**CanWhite Sands – Silica Sand Extraction Project
Environment Act Proposal –
File No. 6119.00
Public Comments Received From**

**Comments re: Manitoba Environment Act Proposal
Public Registry 6119.00
CanWhite Sands Corp. Silica Sand Extraction Project**

E. Pip, BSc (Hons.), PhD

7 October 2021

Figure 14. Drain valve between well line (on right) and captive air tank on 40 year old plumbing. Photo: E. Pip

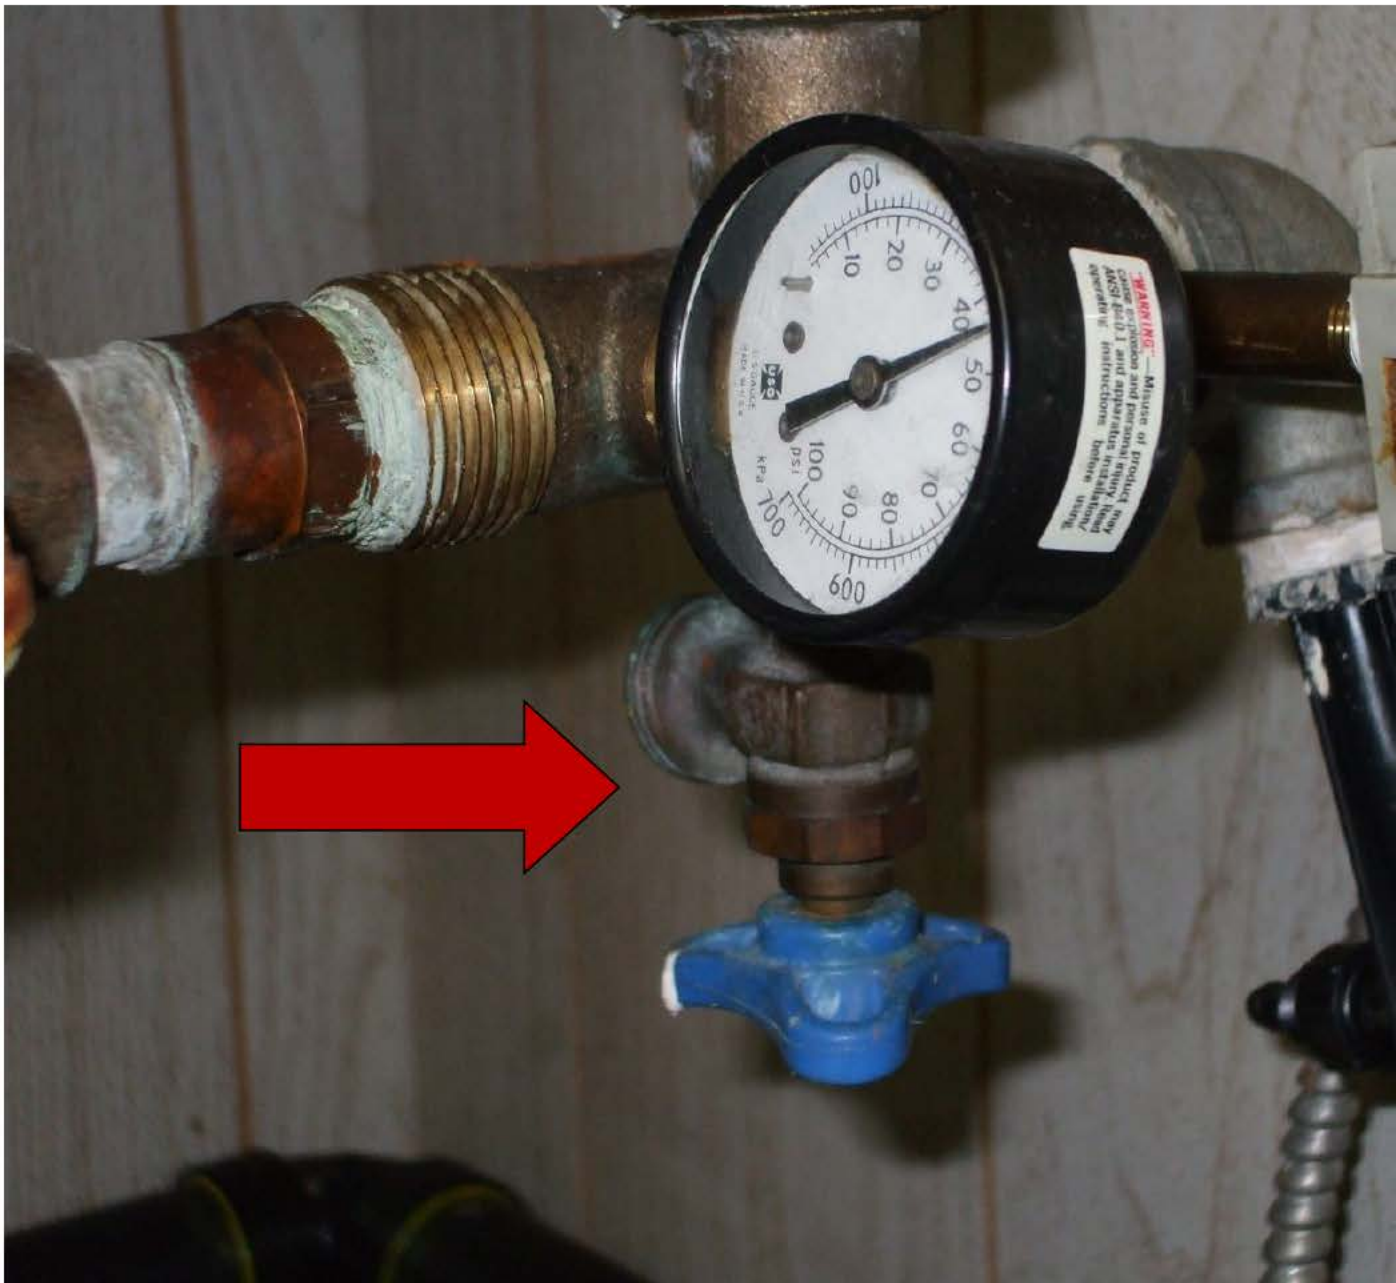
A concern regarding water sampling methodology is raised by the following: “Groundwater samples from select residential water wells were collected from a point of consumption within the house (e.g. tap in kitchen). Samples could not be collected directly from the residential water wells because downhole equipment and wiring obstructed sampling equipment.” (AppA1, p. 46). Evidently these systems had no drain valve between the well and the captive air tank (Figure 14). This is the ‘next best’ sampling option. A hose can be attached at this point, but this is not recommended as it will add potential contamination to the sample.

The above quoted statement regarding sampling at point-of-consumption is remarkable, as many changes and interventions can occur between well and tap, for example:

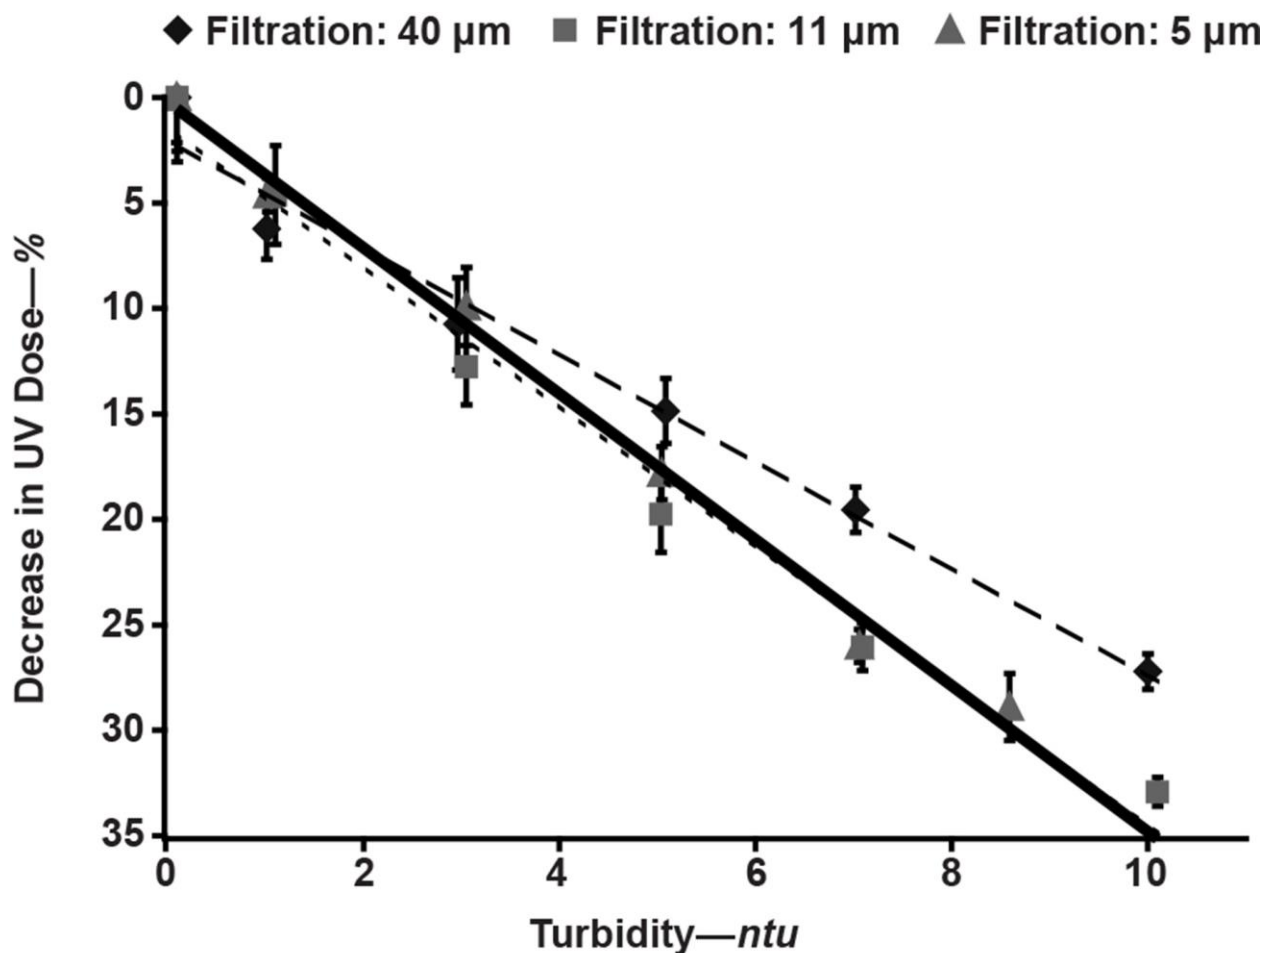
Details of the proposed ultraviolet light treatment in the EAP are significantly lacking. According to EAP1 (p. 11), “The water portion of the sand and groundwater slurry that will be brought to surface through extraction wells will be separated from the sand at the extraction site. This groundwater is then returned to the aquifer via the sand producing well after being treated with UV light.” Therefore onsite UV treatment is proposed.

The EAP1 (pp. 18-19) neglects to disclose any actual information: a simple generic diagram of a UV lamp is provided, but specifics intended for this project are completely absent: the type of mercury arc lamp, the primary wavelengths (200-300 nm are required (McElmurry and Khalaf, 2016)), the radiation intensity, collimated beam or other, and the configuration and size of the reactor chamber. According to the latter workers, flow rates are important because different pathogens vary in their response to UV light and may require threshold exposure times. How will the unit be powered onsite: what failsafe features will be available in the event of power interruption or failure? However these questions are moot, as is explained further below.

UV lamps have a limited, rather short, effective lifespan and must be monitored to ensure they are replaced when output starts to decline. For hard waters, such as the present case, UV light can cause carbonate precipitation on the quartz tube and lead to significant declines in effectiveness, therefore the lamp needs to be continually cleaned (USEPA, 1999).

Figure 20. Zones of light pollution from an artificial light source. Source: <https://www.darksky.org/light-pollution/>

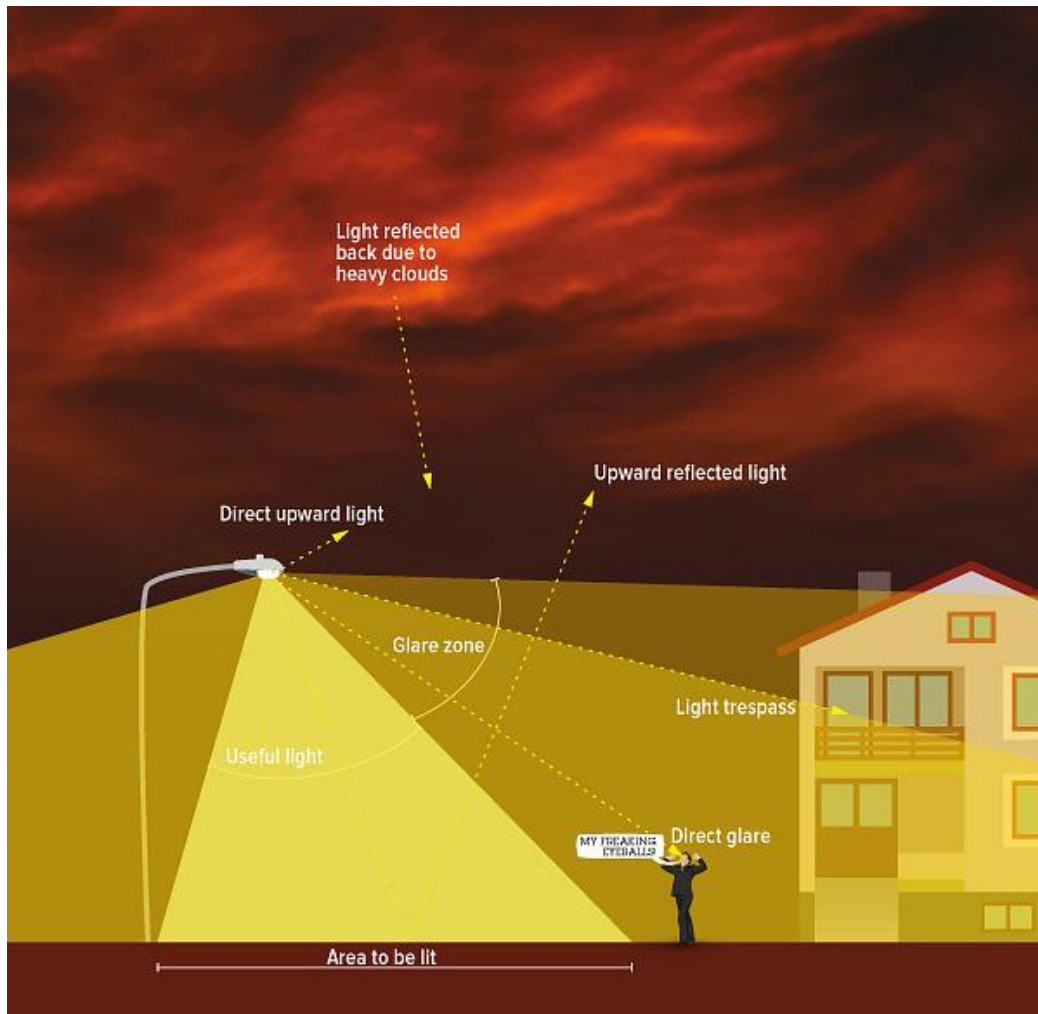
The nuisance of **light pollution** is mentioned only in passing with respect to wildlife, but no reference is made to human health: “**Light pollution emanating from the well cluster/work areas within the Project Site can also disturb wildlife and alter natural wildlife behaviour for wildlife that may be present within the zone of influence of site lighting**” (EAP2, section 6.5.2). Since activities will occur round the clock, and drilling year-round, January through December, need for substantial lighting is anticipated.

Light pollution is a recognized adverse impact on human health (Holker et al., 2010), where it may enable cancers (especially breast cancer (Chepesiuk, 2009)), may interfere with hormonal regulatory mechanisms and chronobiology (circadian rhythms), and create stress and psychological/behavioral issues. Not just the intensity of artificial light is important, but also its quality (primary wavelengths). Health effects can occur not just within the lit area itself, but also from peripheral unwanted glare and light bleeding around the lamp (Figure 20).
